ADDENDUM NO. 2

**Coventry Township
NEW FIELD HOUSE
Logan Field
2701 North turkeyfoot Road
Akron, Ohio 44319**

**Prepared by
Four Points Architectural Services, Inc.**

April 29, 2024

INTERIOR ELEVATIONS

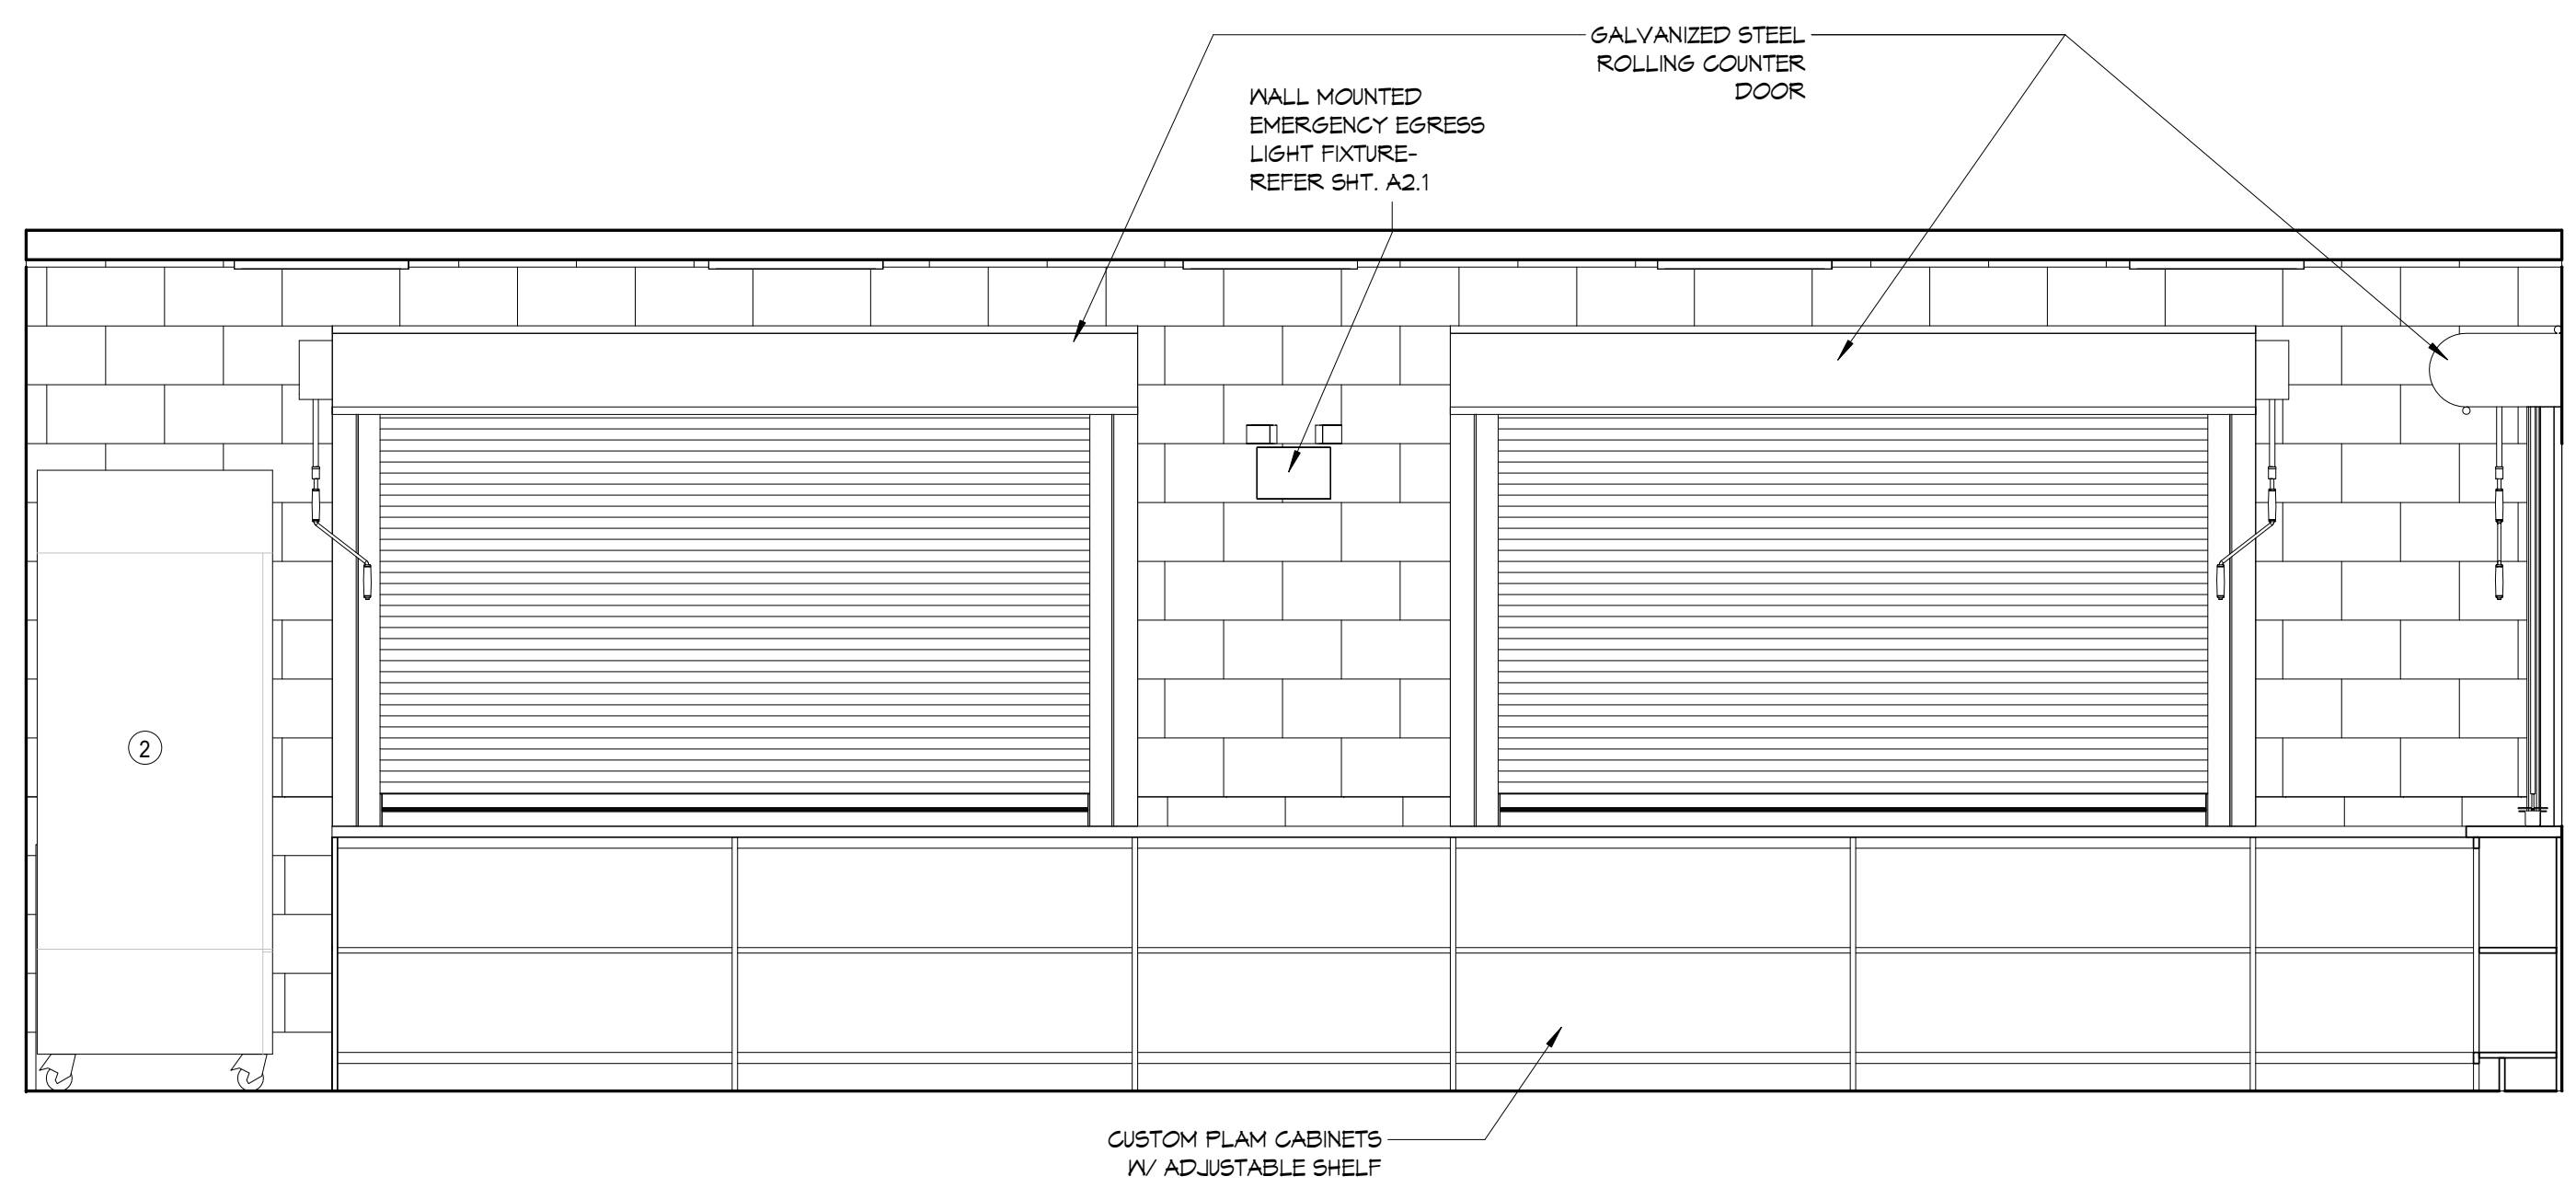
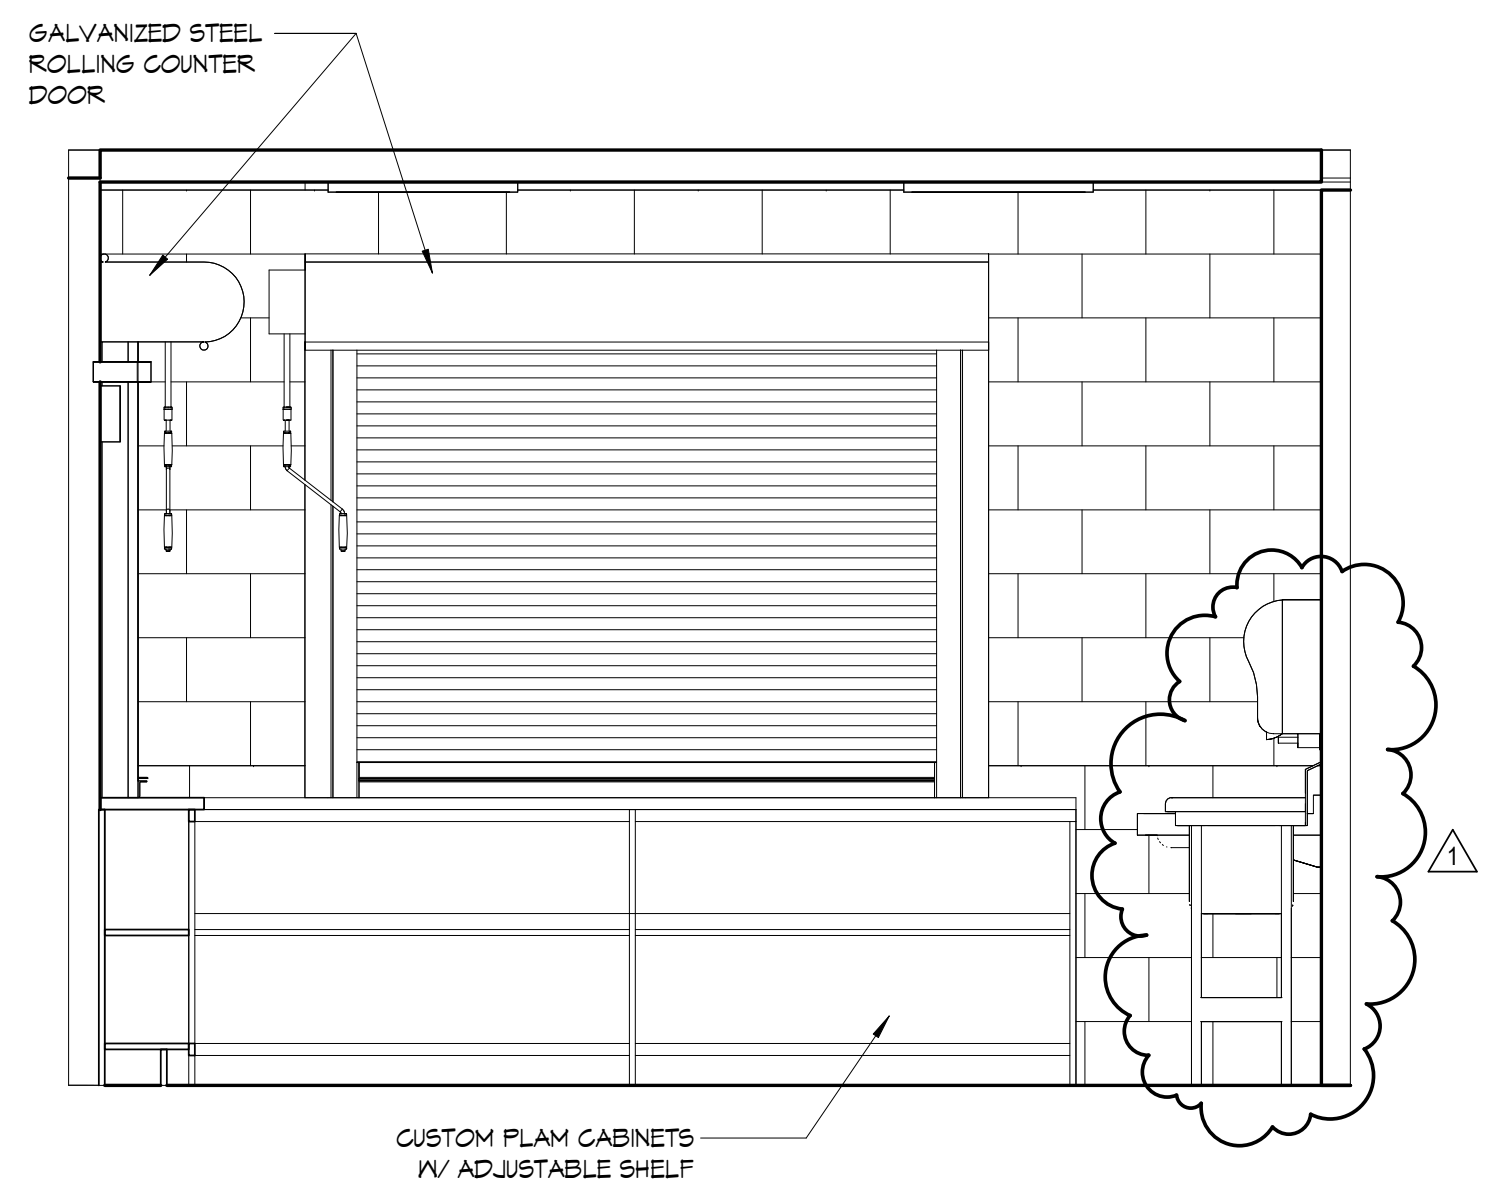
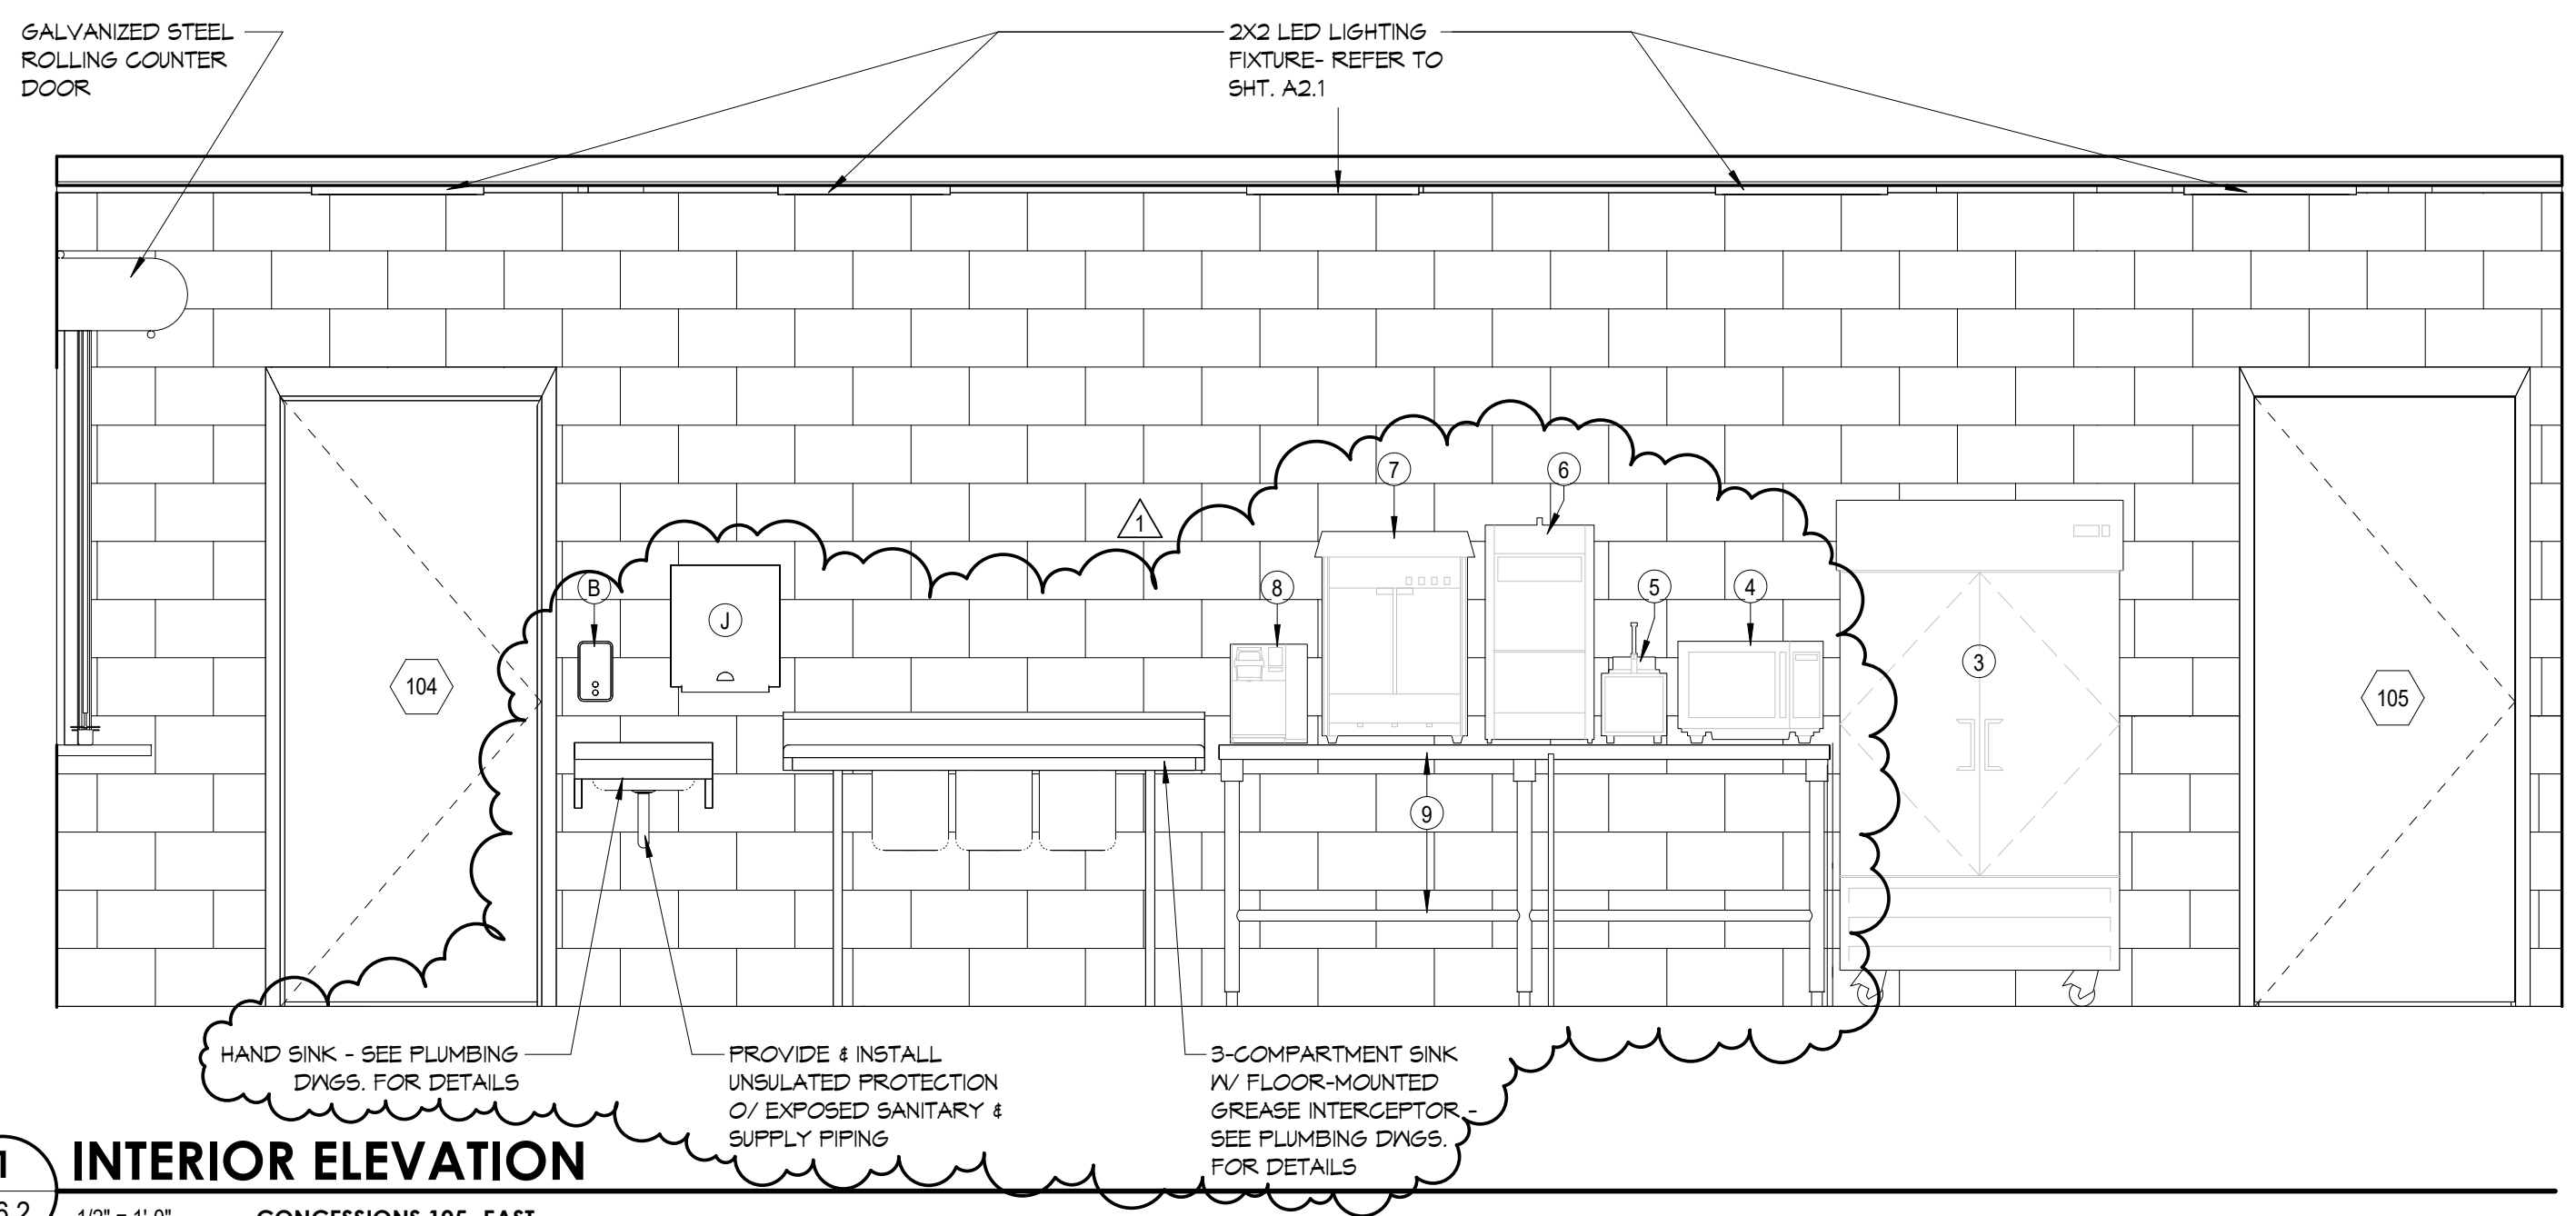
6. **Sheet A6.2 – Interior Elevations:**

- a. The equipment layout shown in the concession stand has been revised.
